22/05714/FB | Expansion of existing cemetery and crematorium to provide new burial and memorial plots with associated roads, footpaths, parking, drainage infrastructure, fencing, landscaping and furniture. | South Bristol Crematorium And Cemetery Bridgwater Road Bristol BS13 7AS

Further comments

Figure 1 Proposed scrub clearance locations outlined in red

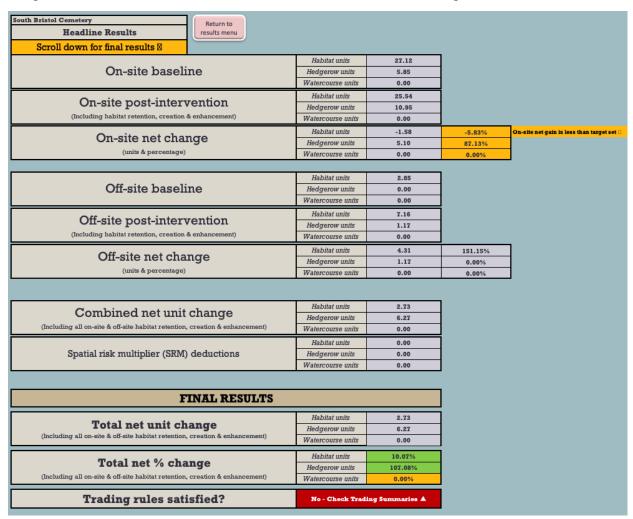
The map at Figure 1 below shows all the areas of scrub on the land controlled by the Council. Yet the proposal states that: 'It should be emphasised that the aim of this management is not to remove scrub entirely from the SNCI - the importance of this habitat type for birds in particular is acknowledged - but to return the balance of habitats closer to the state that it was in when the SNCI was originally designated. The historic cores of hedges and their associated trees will not be affected.'

Is it proposed to remove all of this scrub, or just some of it? We note that some of these areas are within the application Redline area and that some will be lost anyway in order to accommodate the plans for sites 3 and (possibly) site 4 as well as the proposed drain from site 1.

Whatever the answer, the proposed creation of 'islands' of *Lowland meadow* habitat amongst existing grassland habitats does not seem either realistic or practicable. How will these proposals impact the use of the meadows for grazing?
